IN THE MATTER OF THE APPLICATION OF UNS
ELECTRIC, INC. FOR A CERTIFICATE OF
ENVIRONMENTAL COMPATIBILITY FOR THE VAIL TO
VALENCIA 115 KV TO 138 KV TRANSMISSION LINE
UPGRADE PROJECT, ORIGINATING AT THE EXISTING
VAIL SUBSTATION IN SEC. 4, T.16S., R.15E., PIMA
COUNTY, TO THE EXISTING VALENCIA SUBSTATION
IN SEC. 5, T.24S., R.14E., IN THE CITY OF NOGALES,
SANTA CRUZ COUNTY, ARIZONA.

BRIEF OF THE MARSHALL MAGRUDER
REQUEST FOR REVIEW AND EXCEPTIONS TO THE
CERTIFICATION OF ENVIRONMENTAL COMPATIBILITY IN ARIZONA POWER PLANT AND
TRANSMISSION LINE SITING CASE NO. 144

8 September 2009

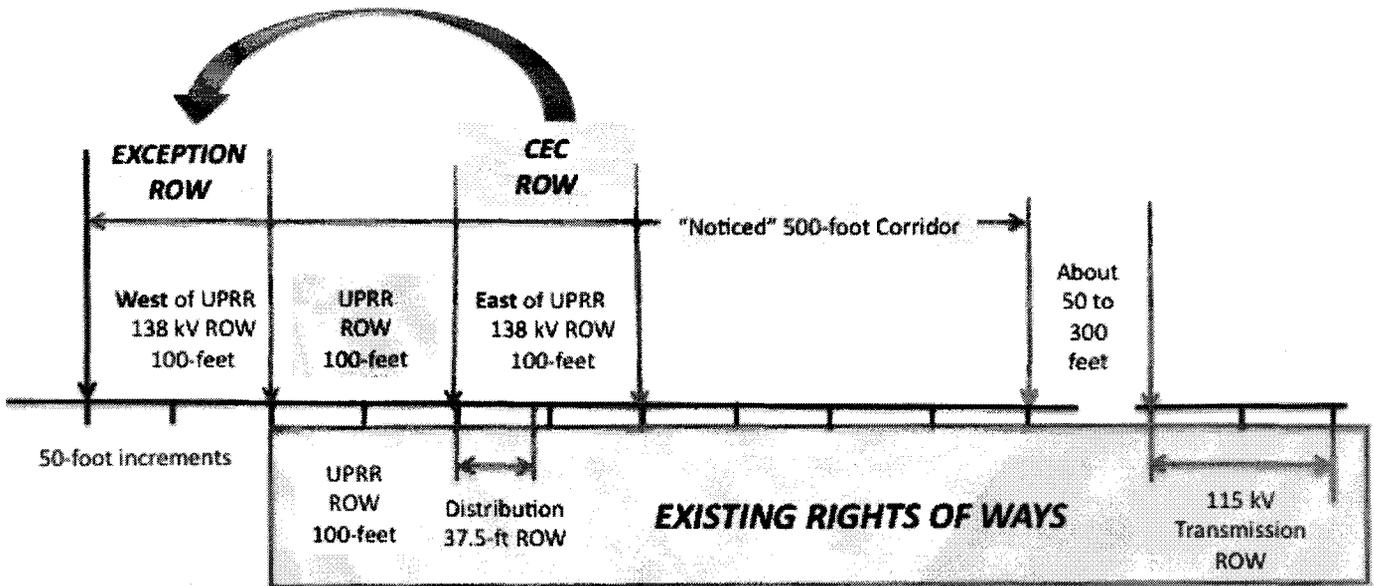
- a. The Exception Alignment involves about 1.3-miles of the entire project and moves the CEC Alignment 200-feet west for about six to eight poles as shown in Map 1, in Black with "tic" marks every 700-750 feet to indicate approximately where a pole might be located. No other part of the project is impacted.
- b. The CEC Alignment expands an existing 37.5-foot distribution line, under-slung on 138-kV transmission line monopoles, into a 100-foot Right of Way (ROW) adjacent and East of the Union Pacific Rail Road (UPRR) 100-foot ROW, in Yellow in Map 1 on page 15.
- c. Figure 1 below is a cross-section of the various easements/Rights of Way when looking north.

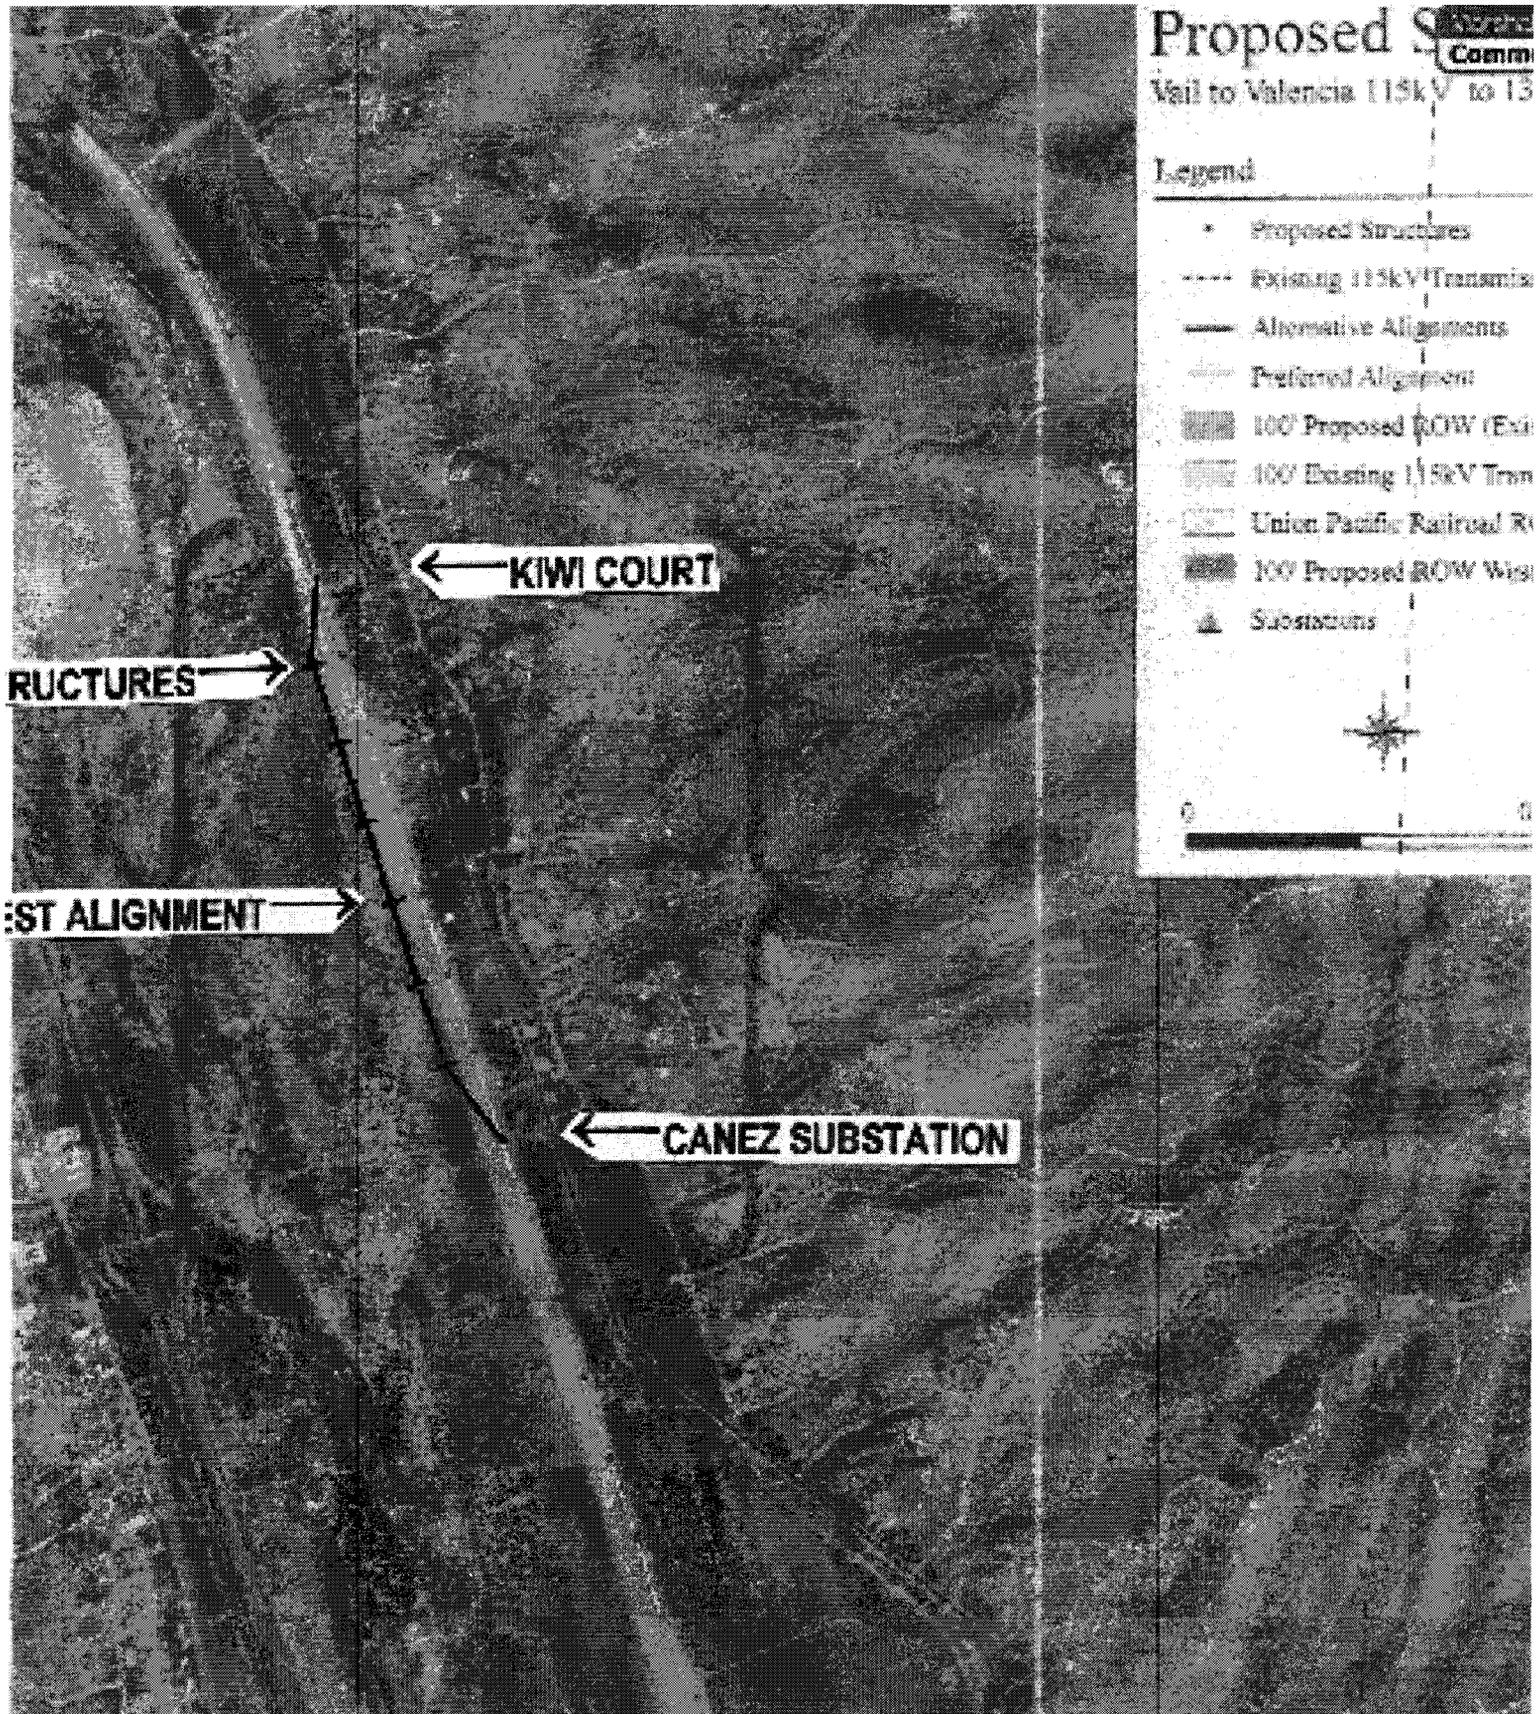
- h. The CEC Alignment is adjacent and east of a 100-foot ROW owned by UPRR, in the Green line shown in Map 1. The Green line also is the company's Preferred Alignment.

- i. The area West of the UPRR ROW is permanent ranch land because its agriculture water rights are essential for Rio Rico homeowners. A ranch road exists the length of this 1.3-mile western boundary of the Railroad and is the Purple line in Map 1 and under the Black line for the Exception Alignment.

- k. The Purple line in Map 1 is the 100-foot Proposed ROW West of UPRR that was discussed at length by the Committee. Based primarily on evidence received in the final hours of the hearing, the Committee, in my opinion, rejected a longer "West of UPRR" option I had proposed, and approved the East ROW, a Green line in Map 1, based on a hasty review, incomplete facts and misleading comments (see below).

- l. Upon re-reading the transcripts, reviewing the evidence presented, Exception One was developed to avoid all the possible causes for the Committee's rejection of the longer "west" (Purple line in Map 1) of the UPRR ROW, with a shorter 1.3-mile proposal (Black line with tics for poles in Map 1) to

- j. Exception One requests the CEC be revised to move the centerline of CEC Alignment 200-feet west, so the new 138 kV ROW boundary is adjacent to the western, instead of the eastern, UPRR ROW boundary.

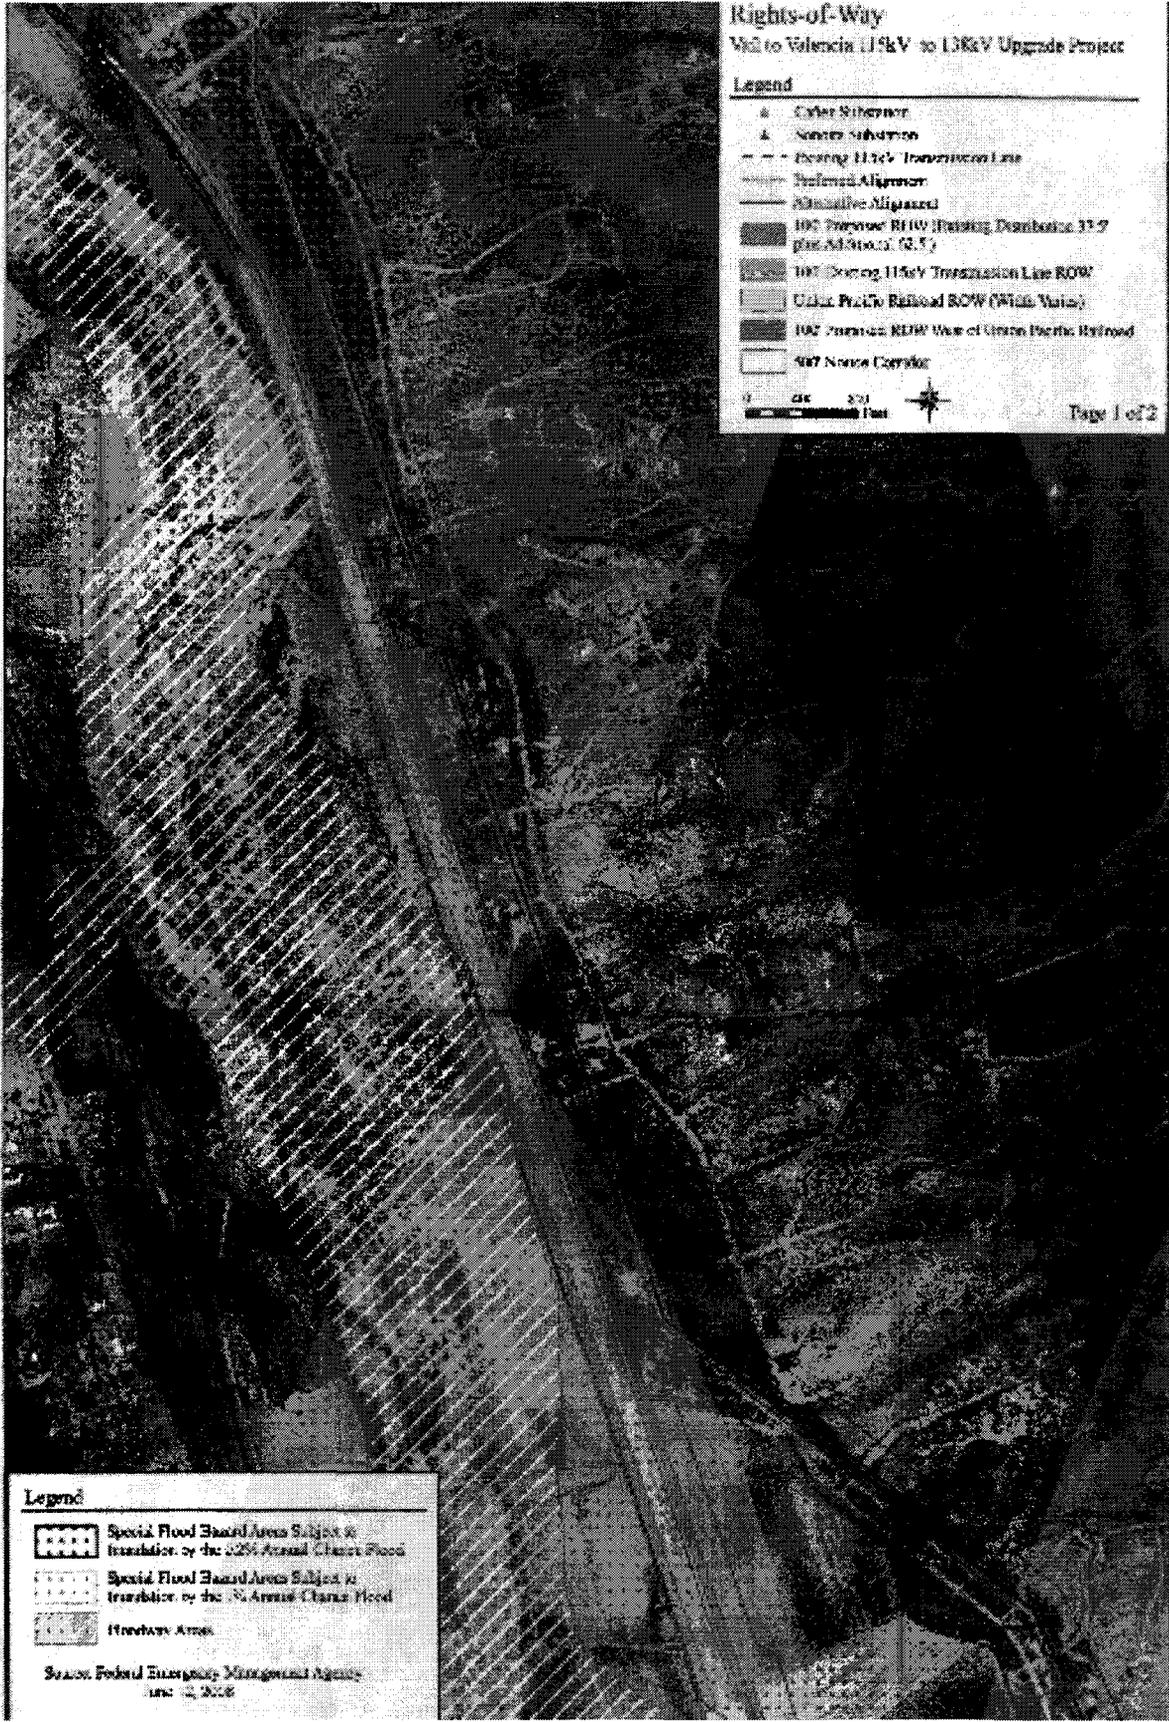
14 (1) The Letter contains two maps provided by UNS Electric to the County Flood District in
15 Enclosure 1 on pages 3 and 4. Hand drawn circles show two “areas of concern” because these locations are
16 where the river floodway may cut through the railroad. (Tr772:1-5)
